Project Narrative

**Cape View Way
Bourne, Massachusetts**

Revised December 21, 2021

Professional Services Corporation, PC (PSC) reviewed the First Submittal of the Site Plans, Stormwater, and related design for the Cape View Way Comprehensive Permit Project (Proposed Project) and issued our peer review memorandum on August 11, 2021.

Figure 3A

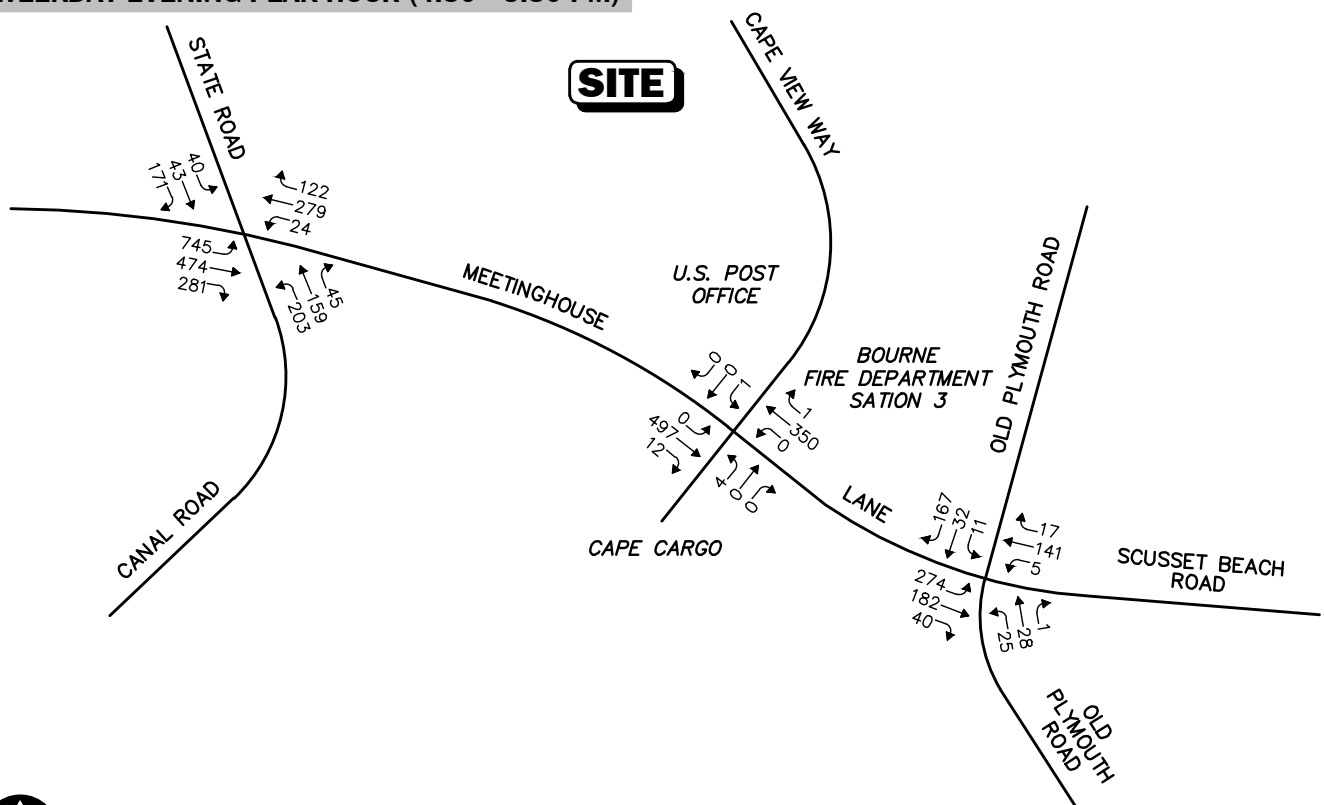
Response: As requested by PSC, an evaluation of peak-season traffic volumes and traffic operations for the roadways and intersections that were assessed in the May 2021 TIA was completed following the methodology outlined by PSC.² Figure 3A depicts 2021 Existing peak-month (July), peak-hour traffic volumes, with Figure 4A depicting 2028 No-Build (without the Project) peak-month peak-hour traffic volumes and Figure 7A depicting the corresponding 2028 Build (with the Project) peak-month peak-hour traffic volumes.

Figure 4A

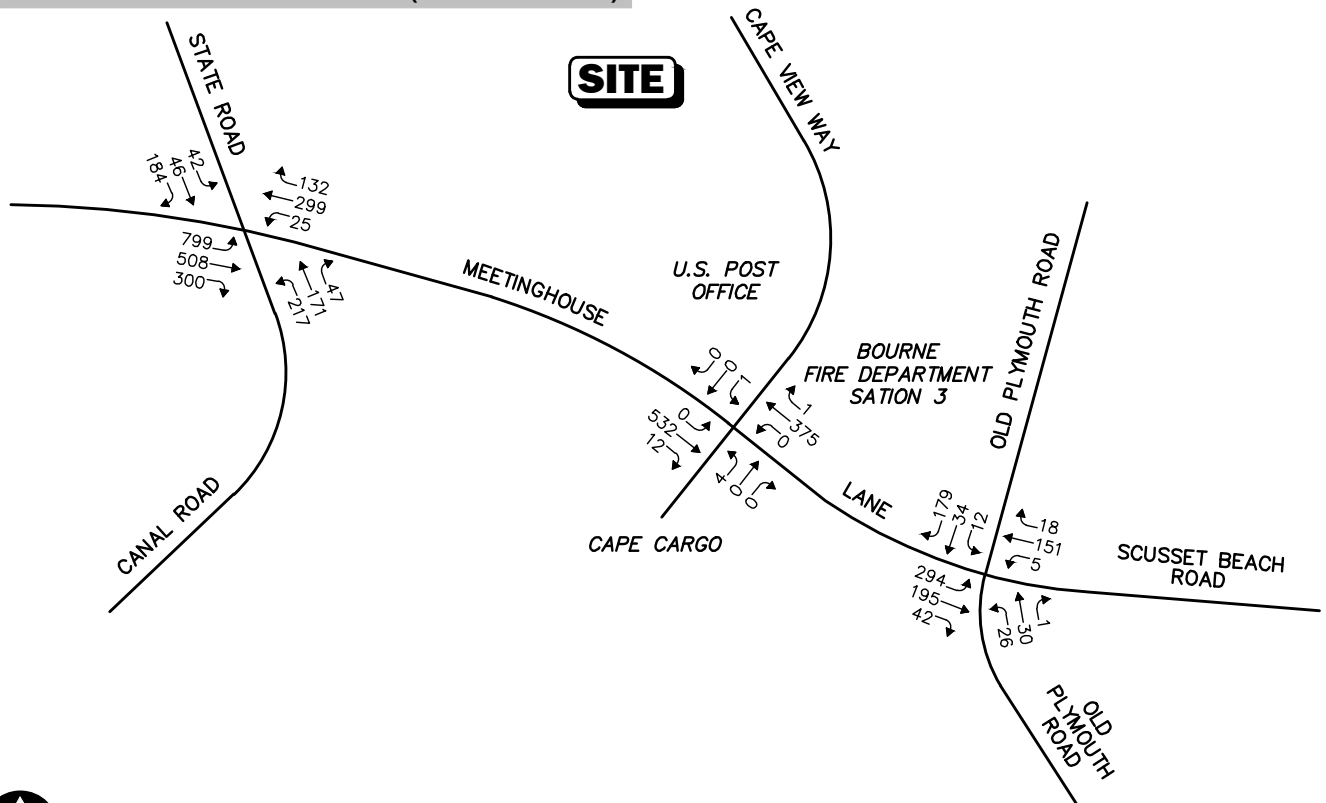
Response: As described previously, Figure 7A depicts the 2028 No-Build (without the Project) peak-month peak-hour traffic volumes.
